Addendum #03

IFB No. 130525 – Building 632
Camp San Luis Obispo - San Luis Obispo, CA
8/6/2026 at 5:00 PM

CAMP SAN LUIS OBISPO BLDG. 632 ROOF REPLACEMENT BID#13052

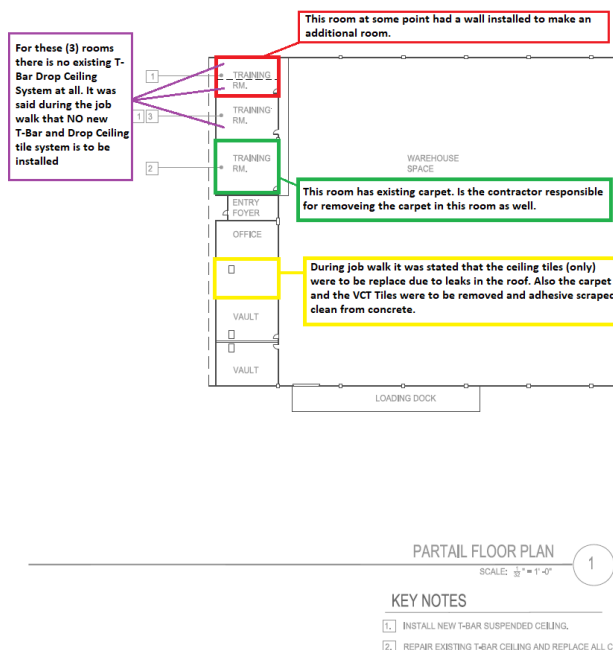
a. We are not overlaying the existing roof.
- During the job walk it was found that the plans provided were NOT up to date as the north side of the building had (4) rooms vs. what the plan set shows, (3) rooms.

- The (3) rooms in purple do not have any T-Bar Drop Ceiling system in them. It was stated on the job walk that “NO new Drop-Ceiling System” was to be install contradicting the “Partial Floor Plan” provided to the contractor. Please confirm whether a new Drop Ceiling System will in fact be install in the (3) rooms as depicted in Purple

- Refer to the drawings. The keynotes are specific to each room.*
- According to the “Partial Floor Plan” provided to the contractor, No Carpet is scheduled to be removed from the room in “Green”. This room has existing carpet, please confirm if the contractor is to remove the carpet of leave in place.

- Contractor is to remove the carpet.*
- During the Job Walk, the contractors were shown the room in “Yellow” and told to include the cost to replace the damaged ceiling tiles (Ceiling Grid to be protected in place) with new. This room also has VCT tile and Carpet and the contractors were instructed to include the cost to remove both (VCT tiles & Carpet) and scrape all adhesive from the concrete floor. This was NOT in the “Scope of Work” provided in IFB No. 130525. Please confirm if the contractor is to include this in the Base Bid.

- a. We have provided the updated drawings with CSFM approval.*
- The room in "RED" looks to have had a wall erected to create the fourth room.
a. Refer to the updated drawings.

- Contractor shall include this work in the base bid.*

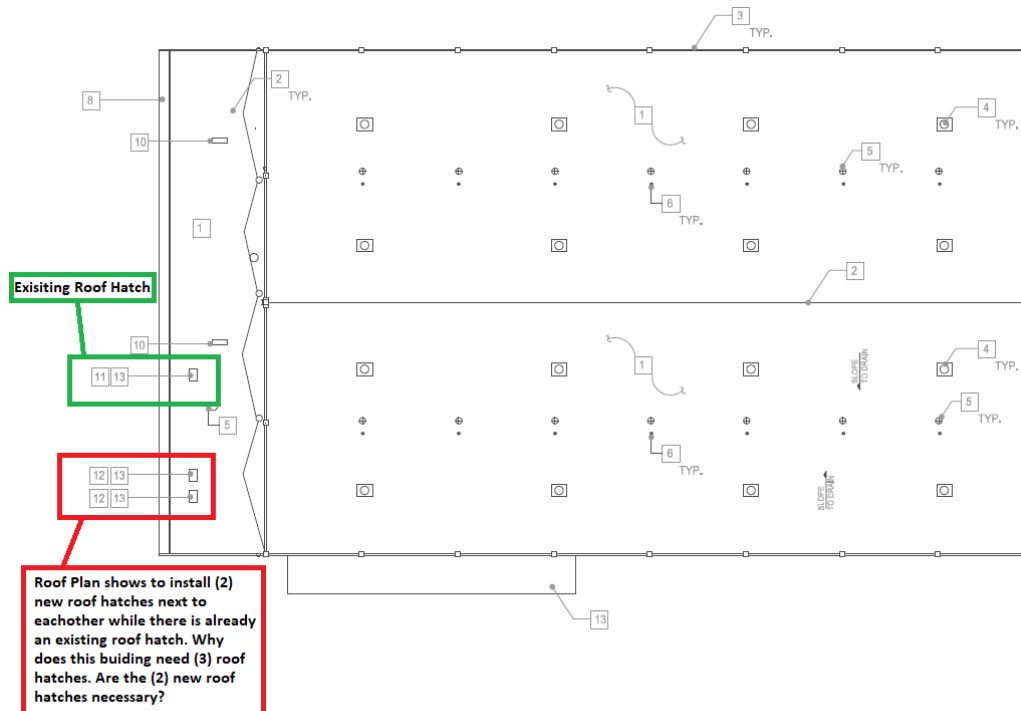
- There is an existing roof hatch that is currently as depicted in Green. The “Roof Plan” shows to install (2) new roof hatches side by side, depicted in Red. For such a small roof there really is no reason to install so many roof hatches. Please confirm that the contractor is required to install the (2) new roof hatches as per “Roof Plan” provided by the Department of the Military.

a. *The State Fire Marshal wanted these two hatches so include them in the base bid.*
